AIRCREW  
PROTECTIVE ARMOR

SUBJECT: Final Report - Aircrew Protective Armor

SUBJECT: Letter Report of Evaluation - Aircrew Protective Armor  
(ACA 55/67I)

FIGURE 1 - FRONT VIEW

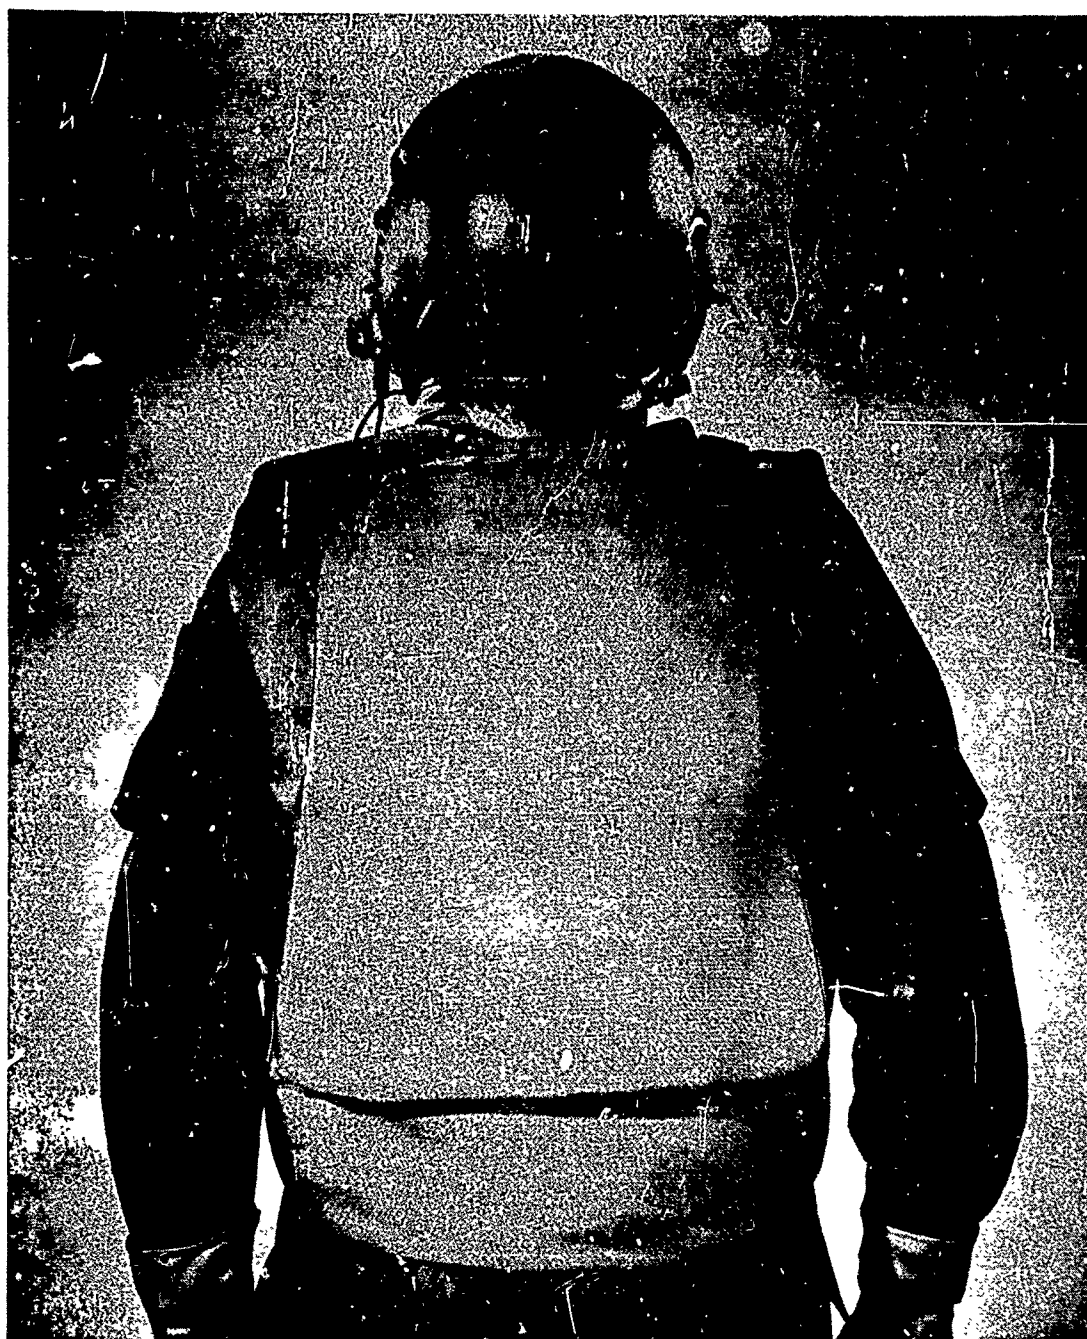
Headquarters USARV concurs with the findings, conclusions, and recommendations contained in the attached report except to clarify in para 10 a(3) that crewchief and gunner seats are not equipped with armor back rest; therefore, the fire retardant mesh back (figure 3) is not appropriate for gunner and crewchief use. The vest with back and front plates (figure 2 and 3) is required for these crewmember's protection.

(4) The collar of the new aircrew protective armor, however, hinders head movement and has a tendency to chafe the neck.

(6) The quick release on the right shoulder of the new system makes it more difficult for the pilot (right seat) to remove the vest than would a quick release on the left shoulder. To remedy this condition, a quick release could be provided on both the right and left shoulder. This release would not only increase the ease of removal of the vest in an emergency, but also would provide the aviator the option of wearing only the front portion of the vest, if desired, in flight. To permit the aviator the flexibility of wearing only the front portion of the vest, a fire-retardant mesh back portion could be provided. The mesh back could be designed to fasten to the front portion utilizing the same quick release principle now incorporated in the vest. The mesh back could incorporate the same front flap closures as the vest (Figure 1).

(2) The collar of the new aircrew protective armor hinders head movement, has a tendency to chafe the neck, and therefore should be removed.

(4) The quick release on the right shoulder of the new aircrew protective armor makes it more difficult for the pilot (right seat) to remove the vest than would a quick release on the left shoulder.

(1) Remove collar of vest

(2) Add a quick release device on the left shoulder of vest.

(3) Incorporate a fire retardant mesh back of the variable-armor design, for wear by aviators in flight (Figure 3).
